Addendum No. 1 to IFB 14-54

To: All Parties on Record with the City of Somerville as Holding IFB 14-54,
Selective Demolition at Somerville High School

ADDENDUM NO.1

Repairs to Somerville
High School
Auditorium, Kitchen
and Cafeteria

AD101

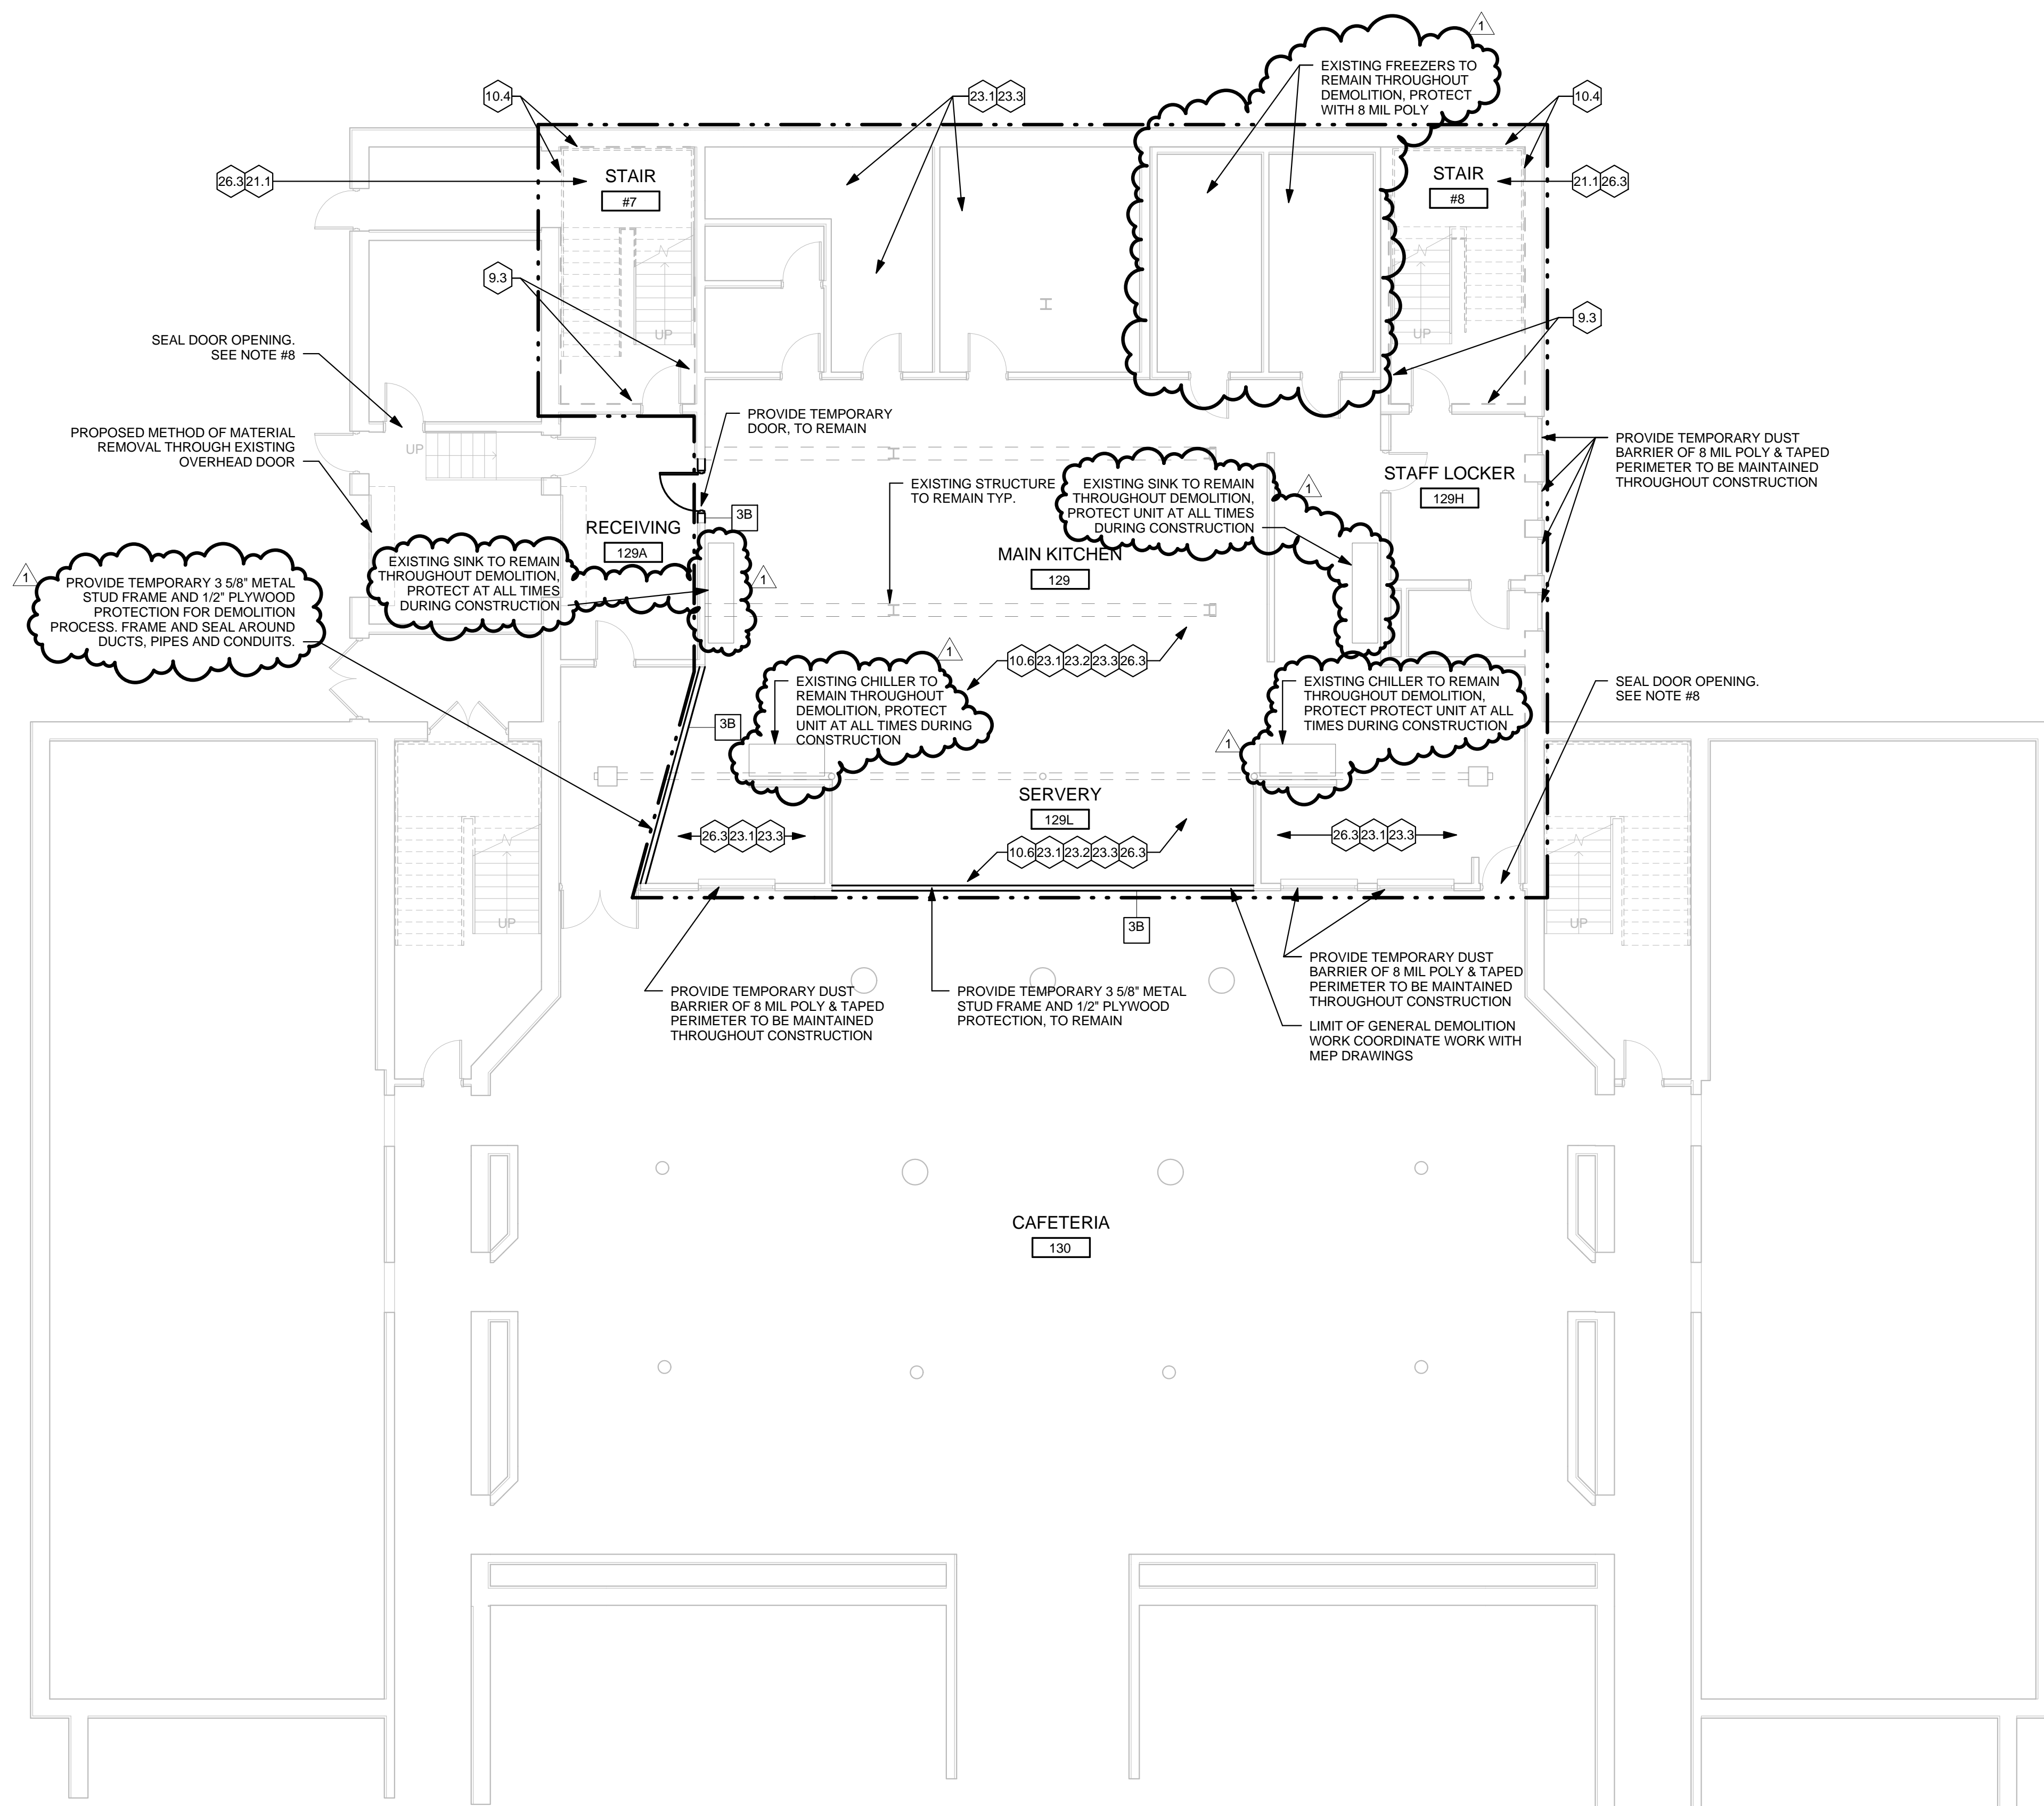
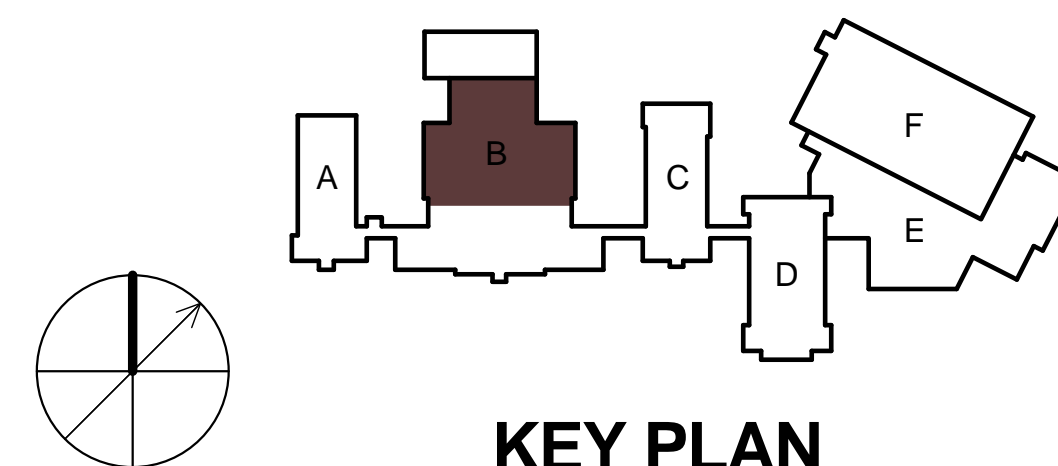
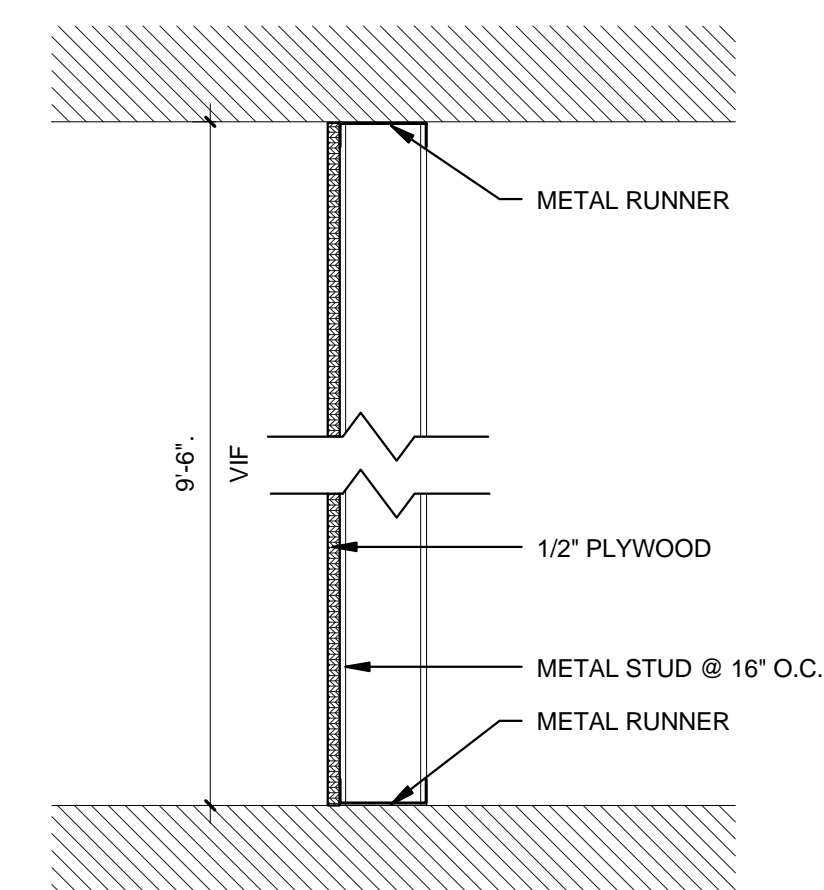
- A. Drawing AD101 CAFETERIA-KITCHEN DEMO FLOOR PLAN
 - 1. MAIN KITCHEN 129, Add note at two existing chillers to read,

“EXISTING CHILLER TO REMAIN THROUGHOUT DEMOLITION. PROTECT UNIT AT ALL TIMES DURING CONSTRUCTION.”
 - 2. MAIN KITCHEN 129, Add note at existing sinks to read,

“EXISTING SINKS TO REMAIN THROUGHOUT DEMOLITION, AT ALL TIMES DURING CONSTRUCTION.”
 - 3. MAIN KITCHEN 129, Add to existing note at 3B wall between Receiving and Main

Kitchen to read,

“PROVIDE TEMPORARY 3-5/8” METAL STUD FRAME AND ½” PLYWOOD PROTECTION FOR DEMOLITION PROCESS. FRAME AND SEAL AROUND DUCTS, PIPES AND CONDUITS.”

AD102

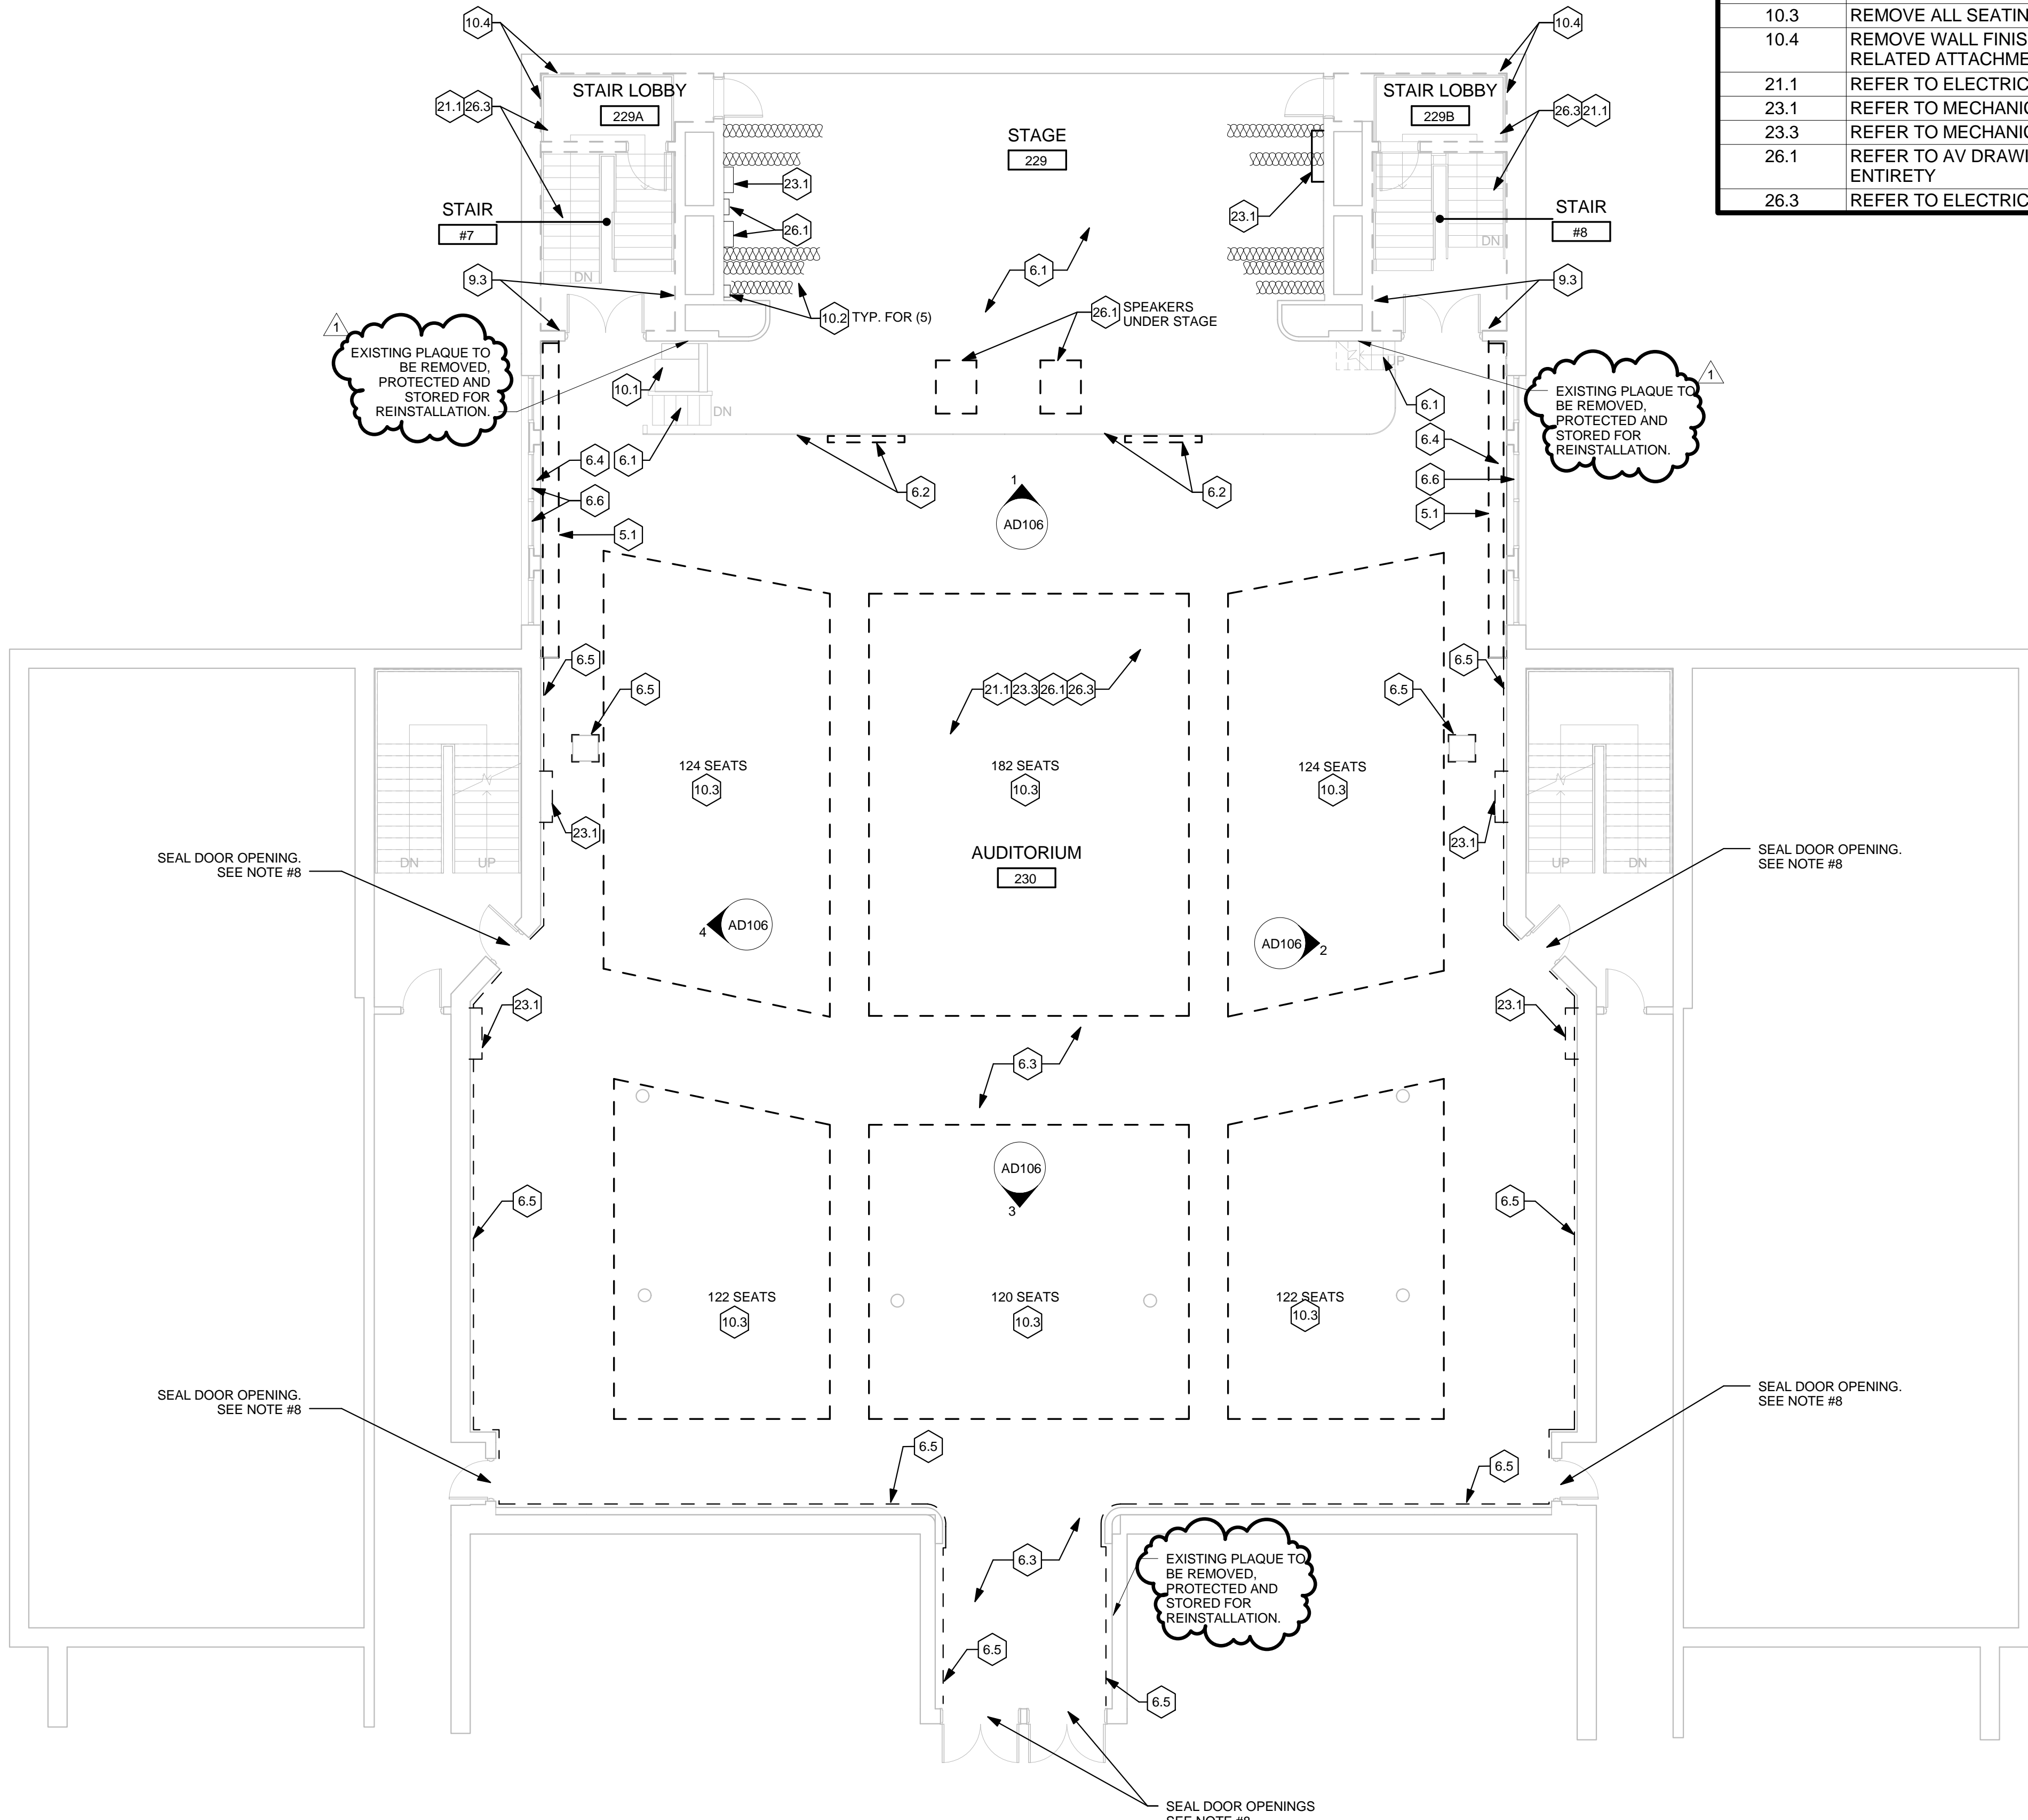
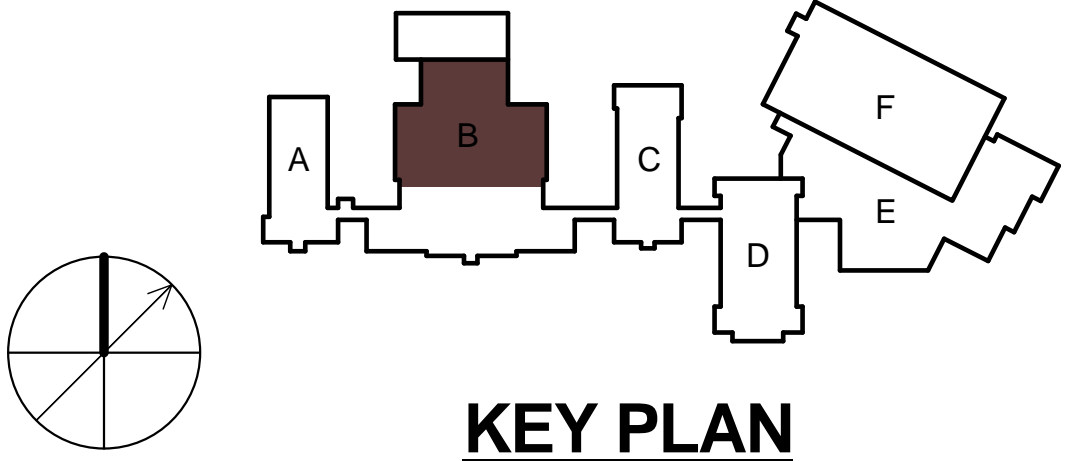
B. Drawing AD102 AUDITORIUM DEMO FLOOR PLAN

1. AUDITORIUM 230, add three notes, for existing plaques, to read,

“EXISTING PLAQUE TO BE REMOVED, PROTECTED AND STORED FOR REINSTALLATION.”
